Dauphin County Subdivision/Land Development Review Report

Municipality	Jackson Township	Surveyor	Burget and Associates	Engineer	
Plat Title	Eric Lutcavage Final Minor Subdivision Plan				
Zoning District	NA	Proposed Land Use	Residential

Project Description: To subdivide 1.8 acres from an existing 37-acre parcel

"SUBDIVISION PLAN"

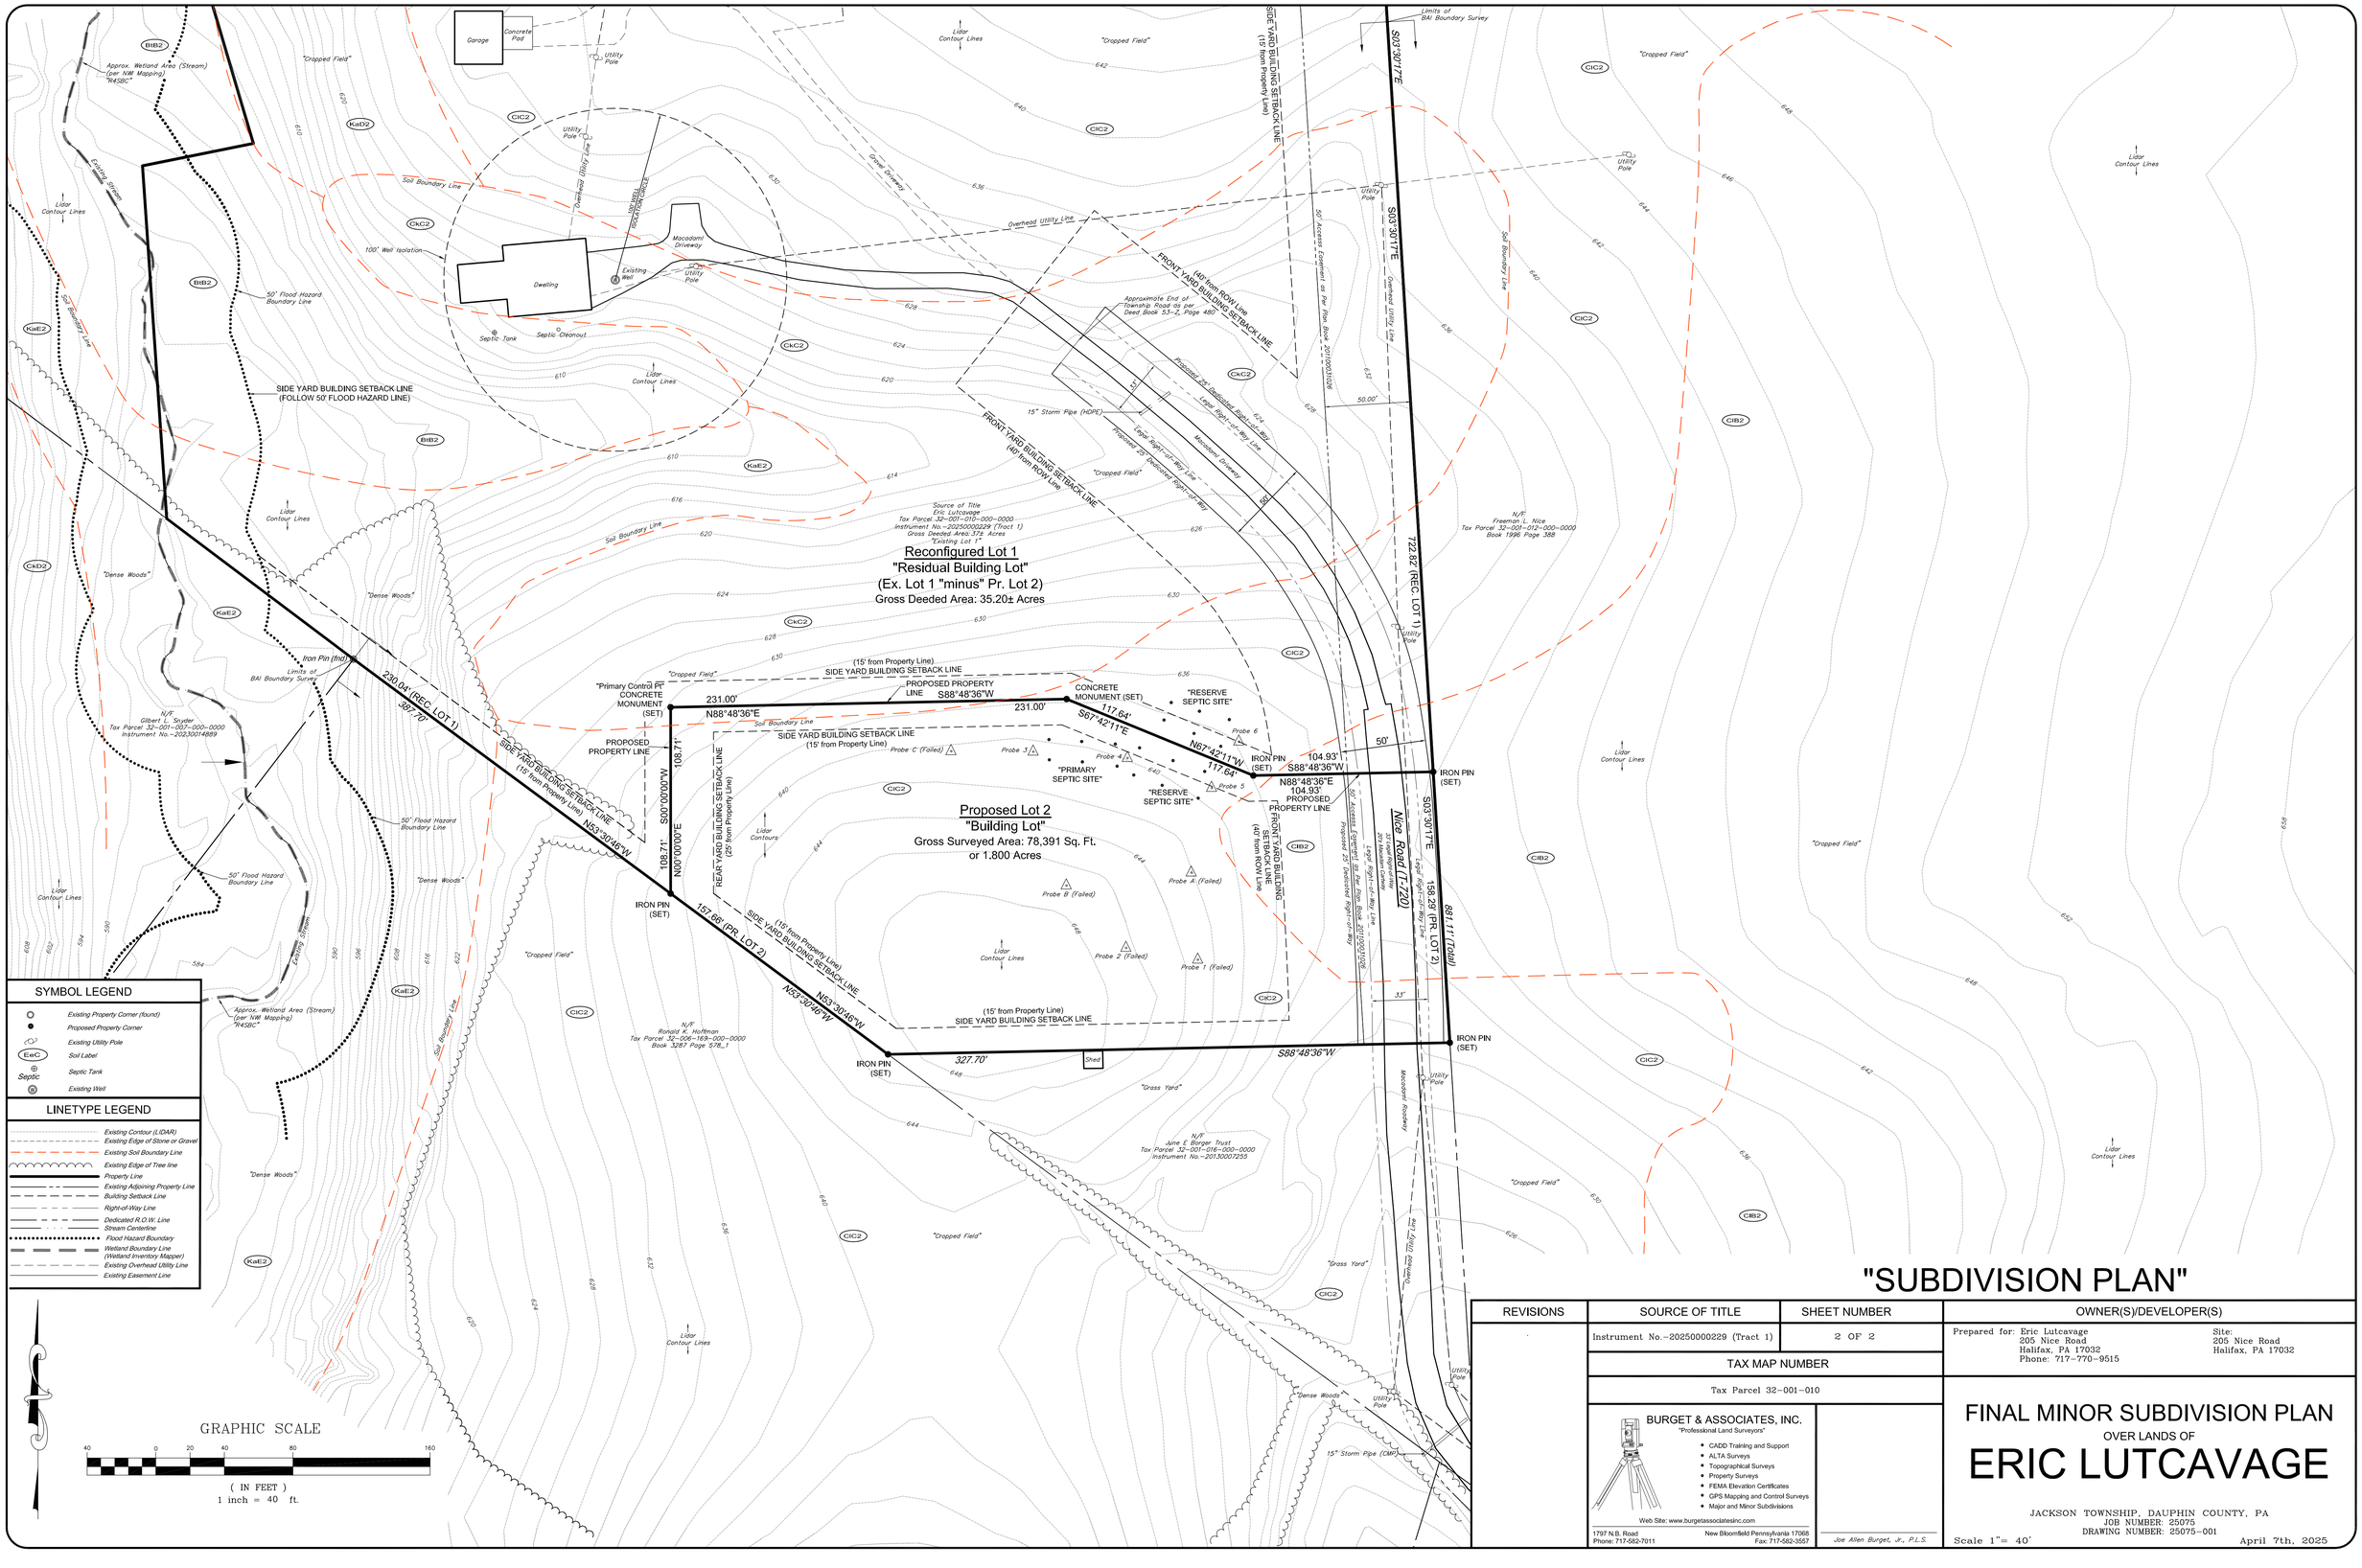
2. No wells indicated (or source for water). If development is to occur – then reasonable assurances are to be provided that the lot can be utilized for future uses. This includes the provision of necessary services including water.

3. There should be certification that the public area / roadway area for Township Road is true and correct (Nice Road – T720). In addition, as there is no turnaround, consultation should be made with township engineers and solicitor on the applicability of the ordinances to provide such a feature since there will be an additional lot.
